**KEVIN M. MARTIN, P.E.**  
**KMM GEOTECHNICAL CONSULTANTS, LLC**

**MEMORANDUM**

**RE: GEOTECHNICAL REVIEW  
PROPOSED RESIDENCE  
22 MONTVALE STREET  
MELROSE, MASSACHUSETTS**

PROPOSED SITE PLAN

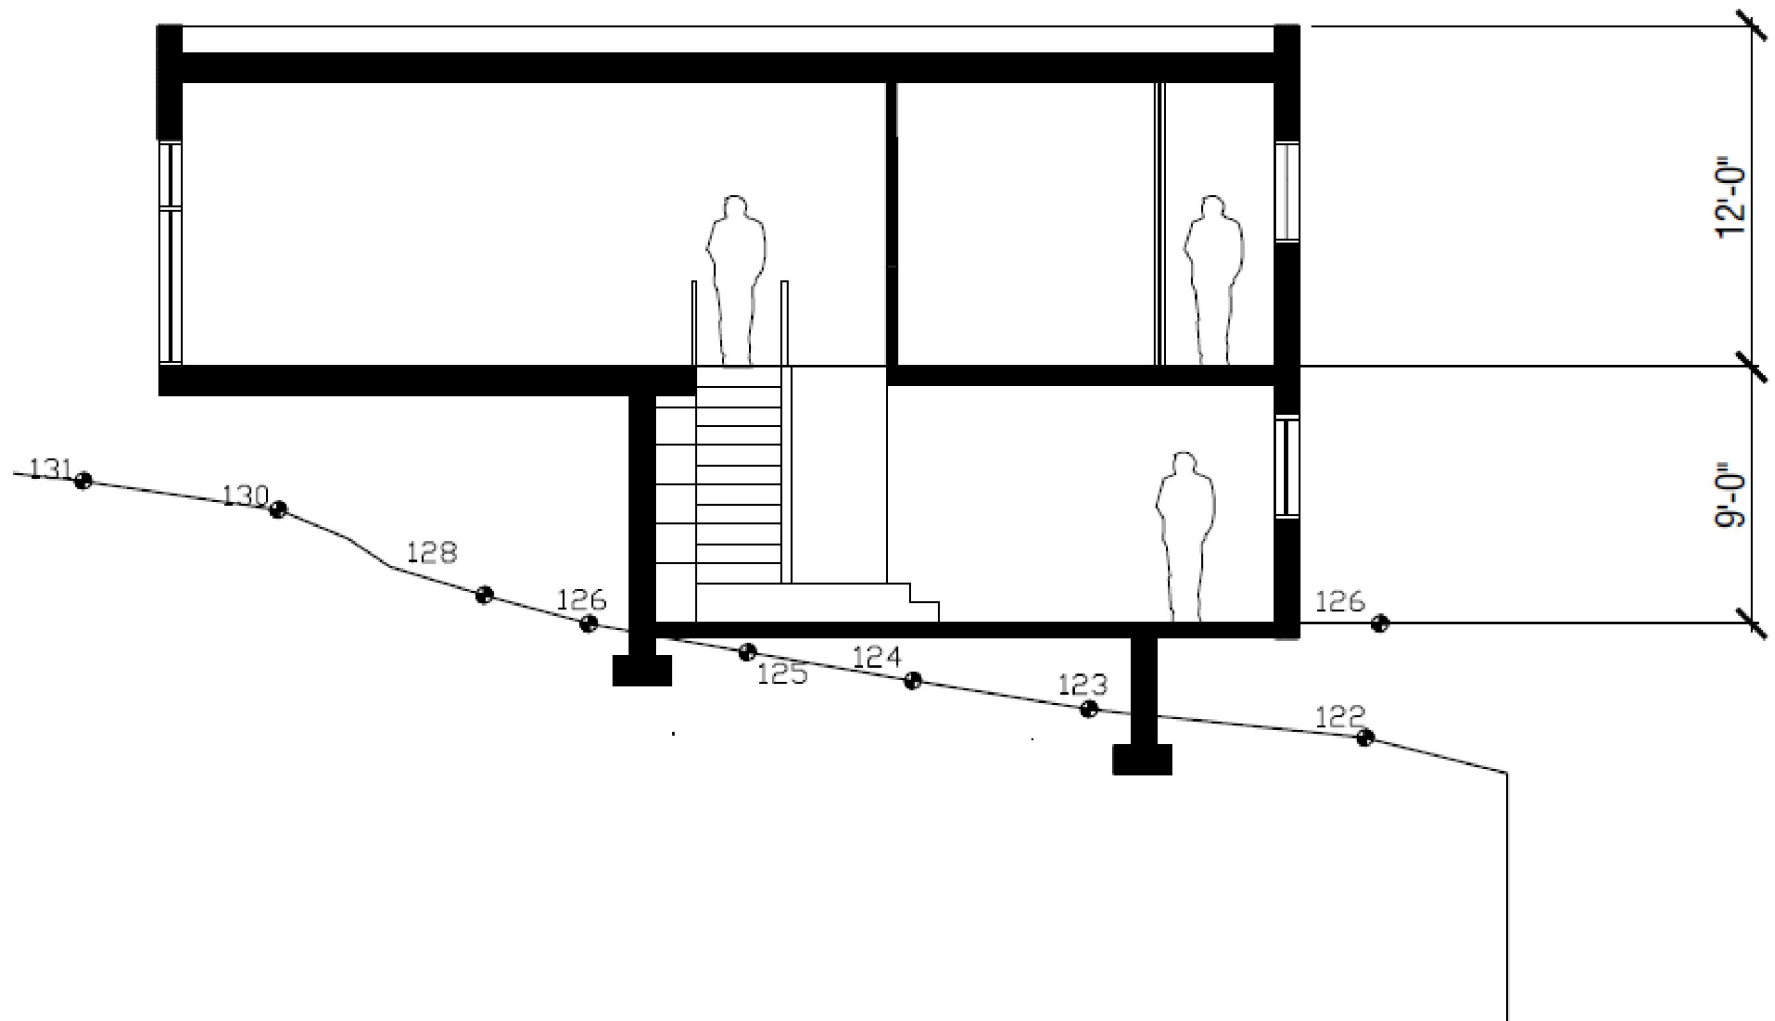
Per the *Site Plan*, it appears building construction can not occur where the slope is steeper than 25%. As such, there is small area where the foundation will be constructed for support of the residence. A Geotechnical Review was requested to review support of the foundation.

**HOUSE PROFILE W/ CANTILEVER**

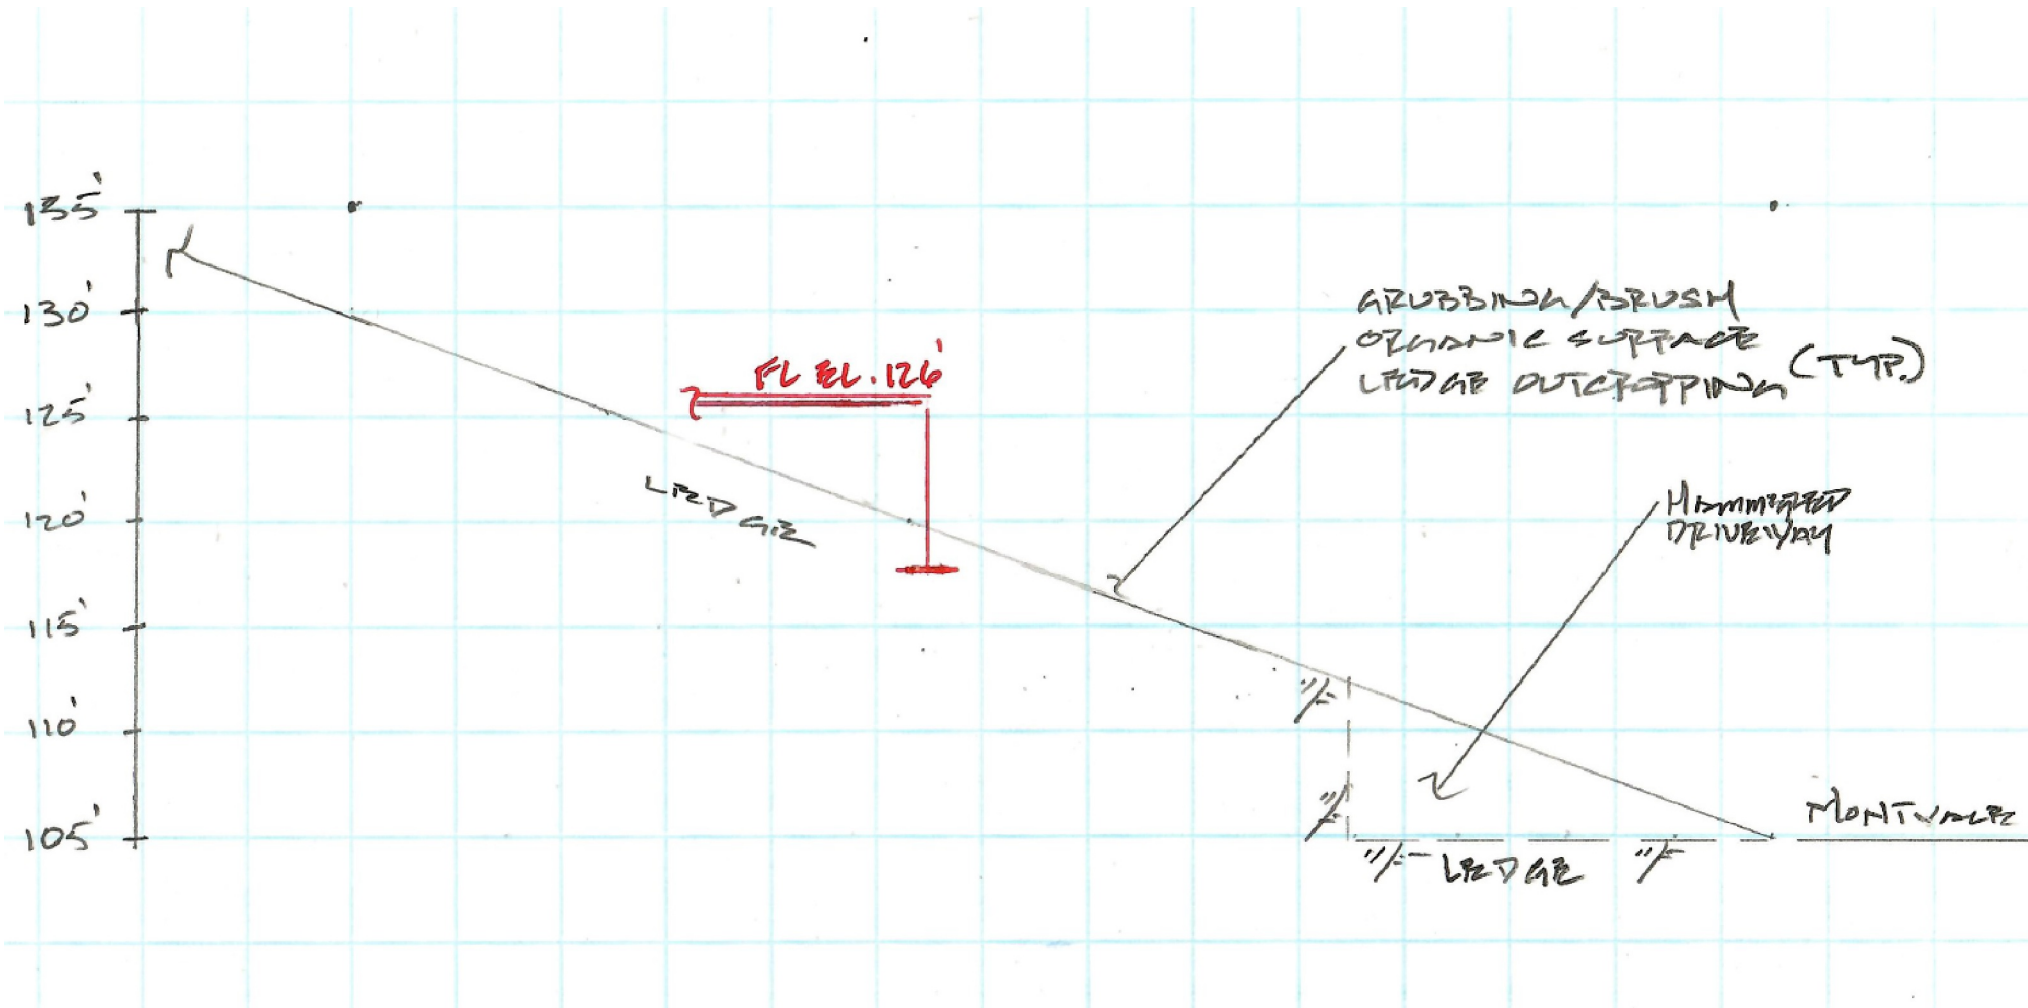
There may be uplift load especially given the cantilevered second floor. Uplift may also be addressed with similar rock anchors. The anchors may be drilled deeper if necessary for additional resistance.
